PRODUCT SUPPORT BULLETIN BULLETIN NO. 350

MACHINE: LS Auto-Lift

SUBJECT: Heat Deflector Kit – 98790021

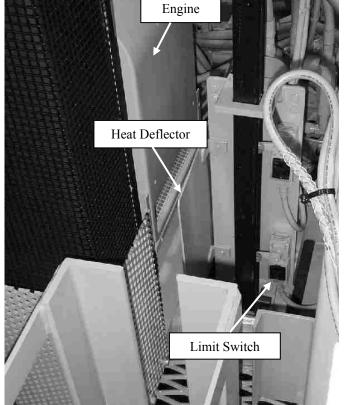
We have experienced some early failures with the Limit Switches on these machines. The switches are located in a position that exposes them to the hot air being blown off of the engine. The hot switches are susceptible to early failure, usually in the open circuit mode. One symptom of this is that the Jacking Cylinder will retract all the way and the machine will not propel. Another symptom is that the machine will lift the rail too high, bypassing the limit switch.

Some machines may already have a heat deflector to shield the operator from the hot engine air. However because it is mounted outside of the switches, this deflector will not shield the Limit Switches from the hot air. The redesigned deflector will replace the original deflector.

A Heat Deflector Kit, p/n 98790021 has been designed to deflect the hot air from the engine away from the limit switches. This will keep the switches cooler and minimize this problem. This kit consists of a new Limit Switch Mounting Plate, p/n 21446104, an Engine Air Deflector, p/n 29420198, hardware and installation instructions.

the machine and can be installed in an hour or so with ordinary hand tools and does not require any welding. Machines S/N 790641 and up were built with this Heat Deflector.
